Appl. No. 10/660,084
Amdt. dated November 17, 2004
Reply to Office action dated August 17, 2004

REMARKS AND ARGUMENTS

Amendments to the Drawings:

FIG. 1 (PRIOR ART)

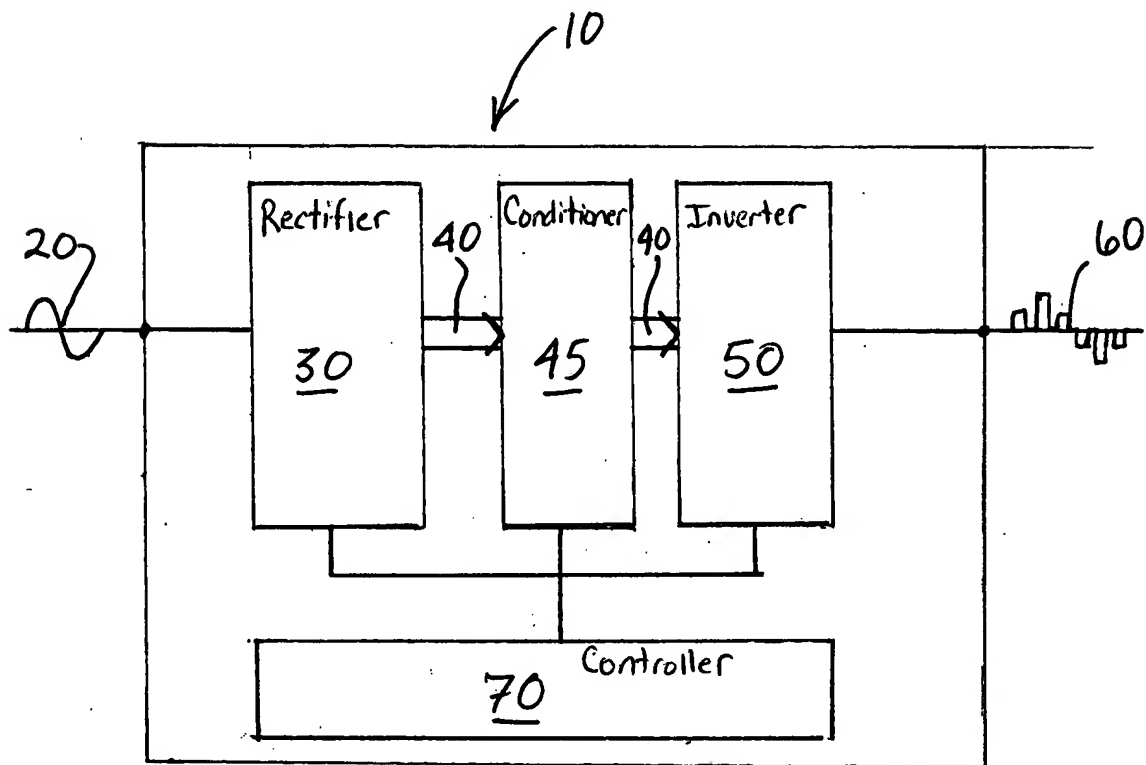
(a) The boxes need to be labeled. For example, in Fig. 1, the box referenced, as 30 should be labeled "Rectifier" the box referenced, as 45 should be labeled "Filter", and so on for the remainder of the boxes and figures.

(c) Figure 1 should be designated by a legend such as —Prior Art— because only that which is old is illustrated. See MPEP § 608.02(g).

Applicant has amended Figures 1, 2 and 3 by labeling each box with its appropriate name in accordance with Rule 83(a). No new matter has been added.

Applicant has amended Figure 1 by adding a "Prior Art" legend.

The attached sheets of drawings include changes to Figs. 1, 2 and 3. Figure 1 has been amended by adding a "Prior Art" legend and by labeling boxes 30, 45, 50 and 70. Figure 2 has been amended by labeling boxes 110, 120, 140 and 150. Figure 3 has been amended by labeling boxes 230, 240, 280, 290, 310, 320, 340 and 400.

FIG. 3

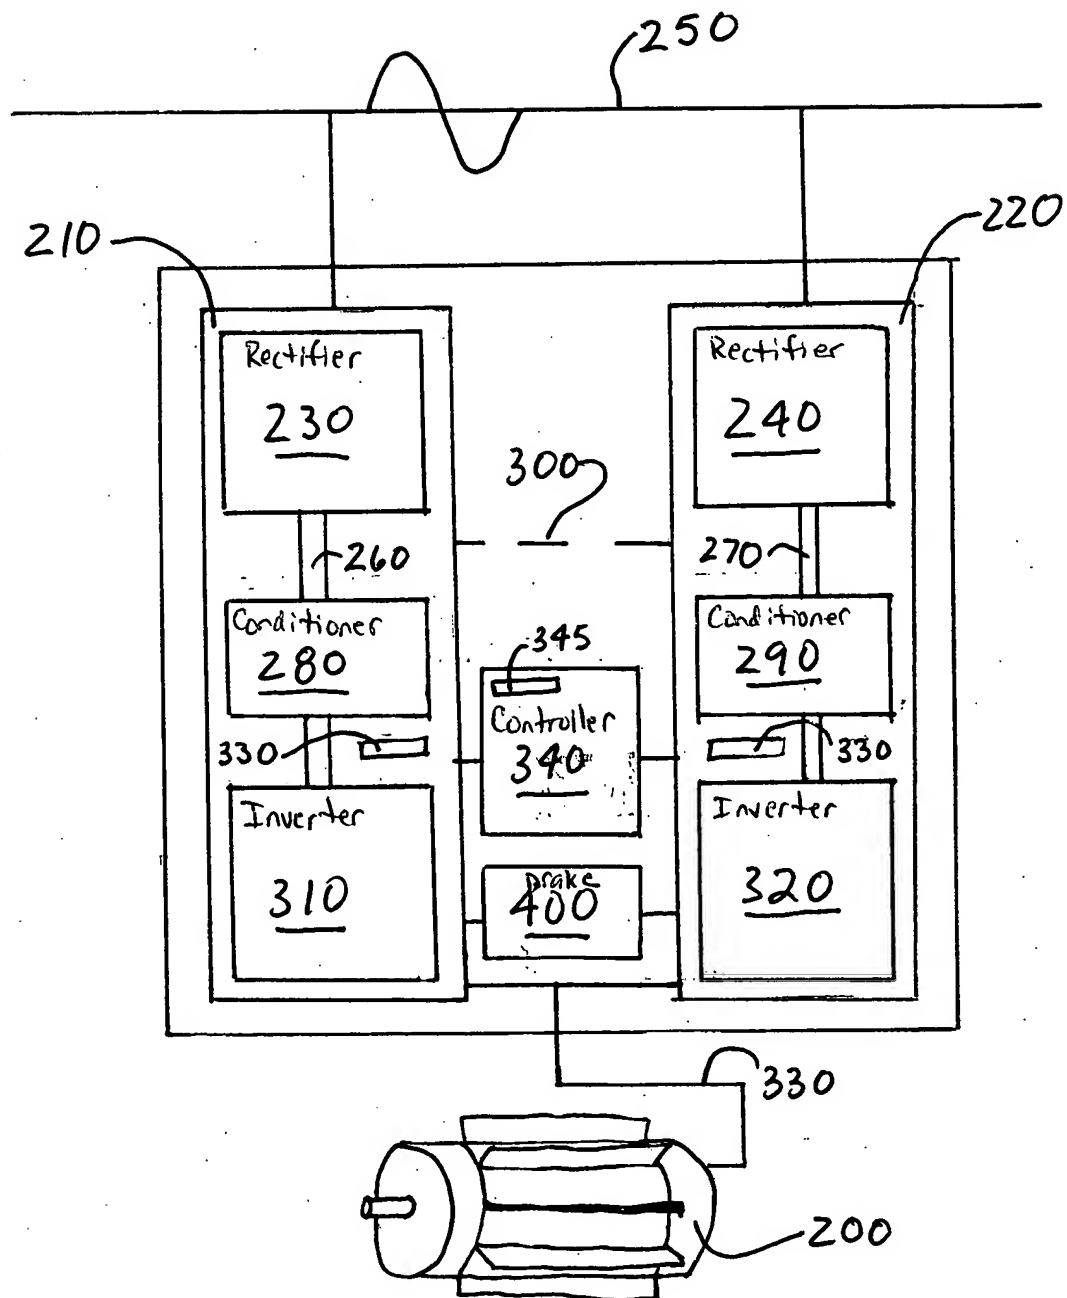
(b) The drawings are objected to as failing to comply with 37 CFR 1.84(p)(4) because reference character "115" has been used to designate both a DC bus and a rectifier interface.

Applicant has amended Figure 3 by changing the reference numeral 115 for the rectifier interface to reference numeral 117. The specification has been conformed to this change as well (see paragraph [0013]). No new matter has been added.
